Author's note: This update incorporates the resolution of other comments related to 120G.3.4.1, which have been resolved or are in the initial bucket.

120G.3.4.1 Module stressed input test

Figure 120G-10—Example module stressed input test setup

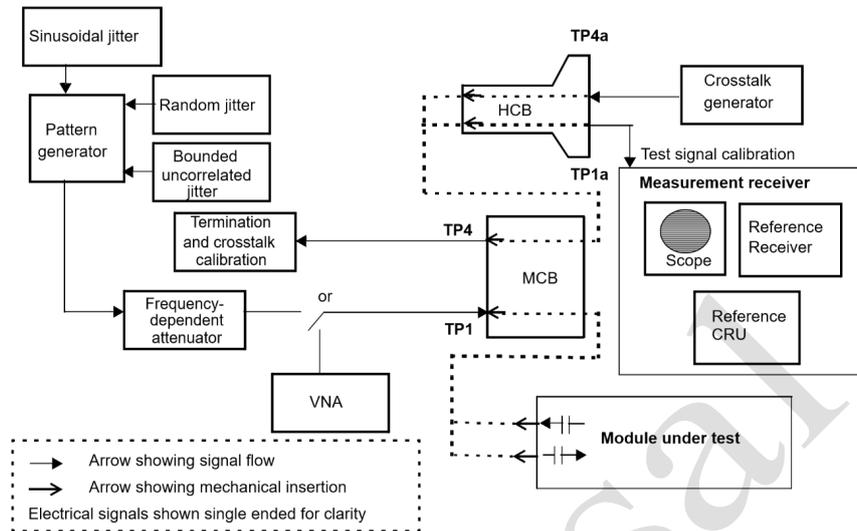
The module stressed input test setup is illustrated in Figure 120G–10. The stressed signal is applied at TP1 and is calibrated at TP1a.

A crosstalk generator for counter-propagating signals representing the module output is used for calibration of the stress. The counter-propagating signals are asynchronous to the pattern generator. This crosstalk generator is not present in the test, being replaced by the output of the module under test.

The test system meets the ERL specification given in 120G.3.1.2 when measured at TP1a.

Commented [AR(5): Comment #140
